VARIANCE APPLICATION FORM

Re: Request for variance to 16500 Jackson St

Site Development Review

Project Site Address: 16500 Jackson Date: May 19, 2014
Permit Applicant: Kerr Residence Project: Residential Application
Zoning District: R-1
Reviewer: Marc Dickey

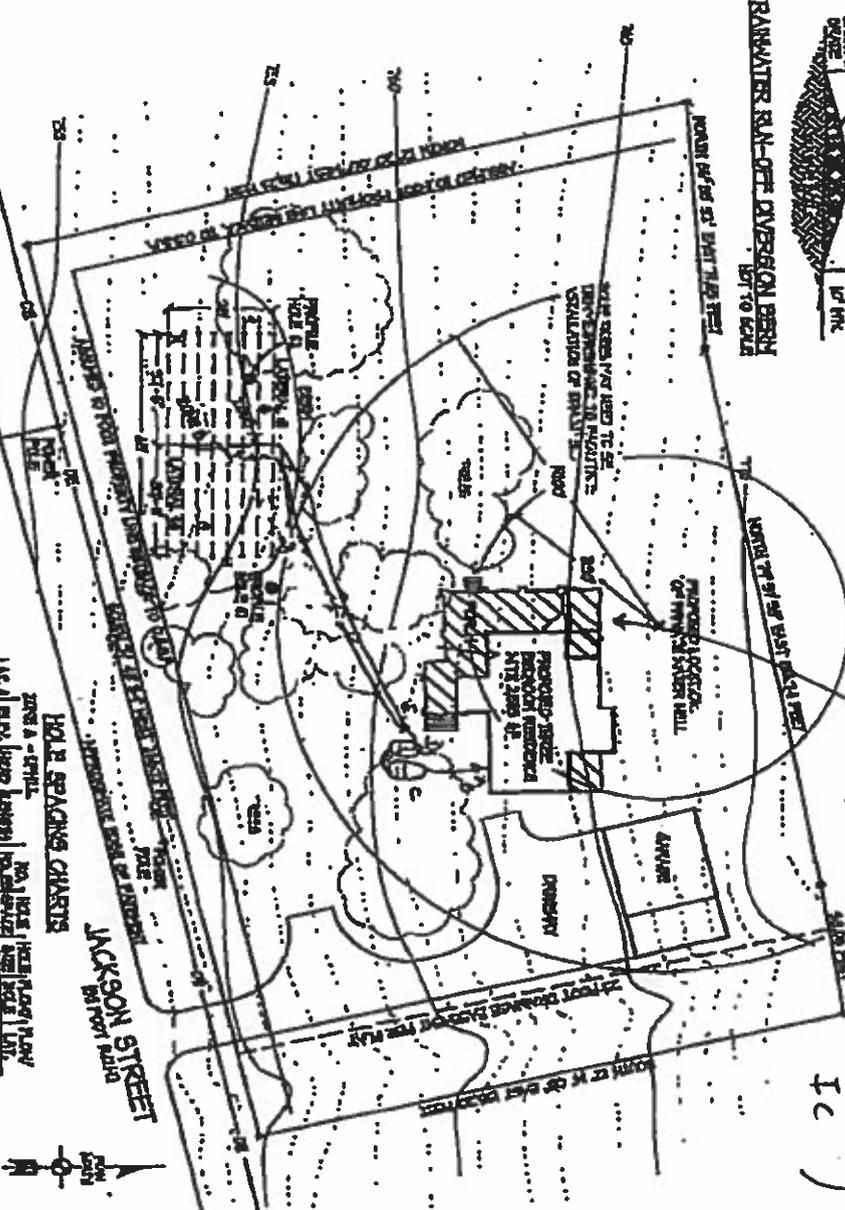
1. It appears the proposed addition to the house will increase the allowable square footage over 20% impervious cover. **A variance must be requested to exceed 20% impervious cover.**
2. FYI: Silt fence will be required along the perimeter of the site area until revegetation of the disturbed areas has occurred.
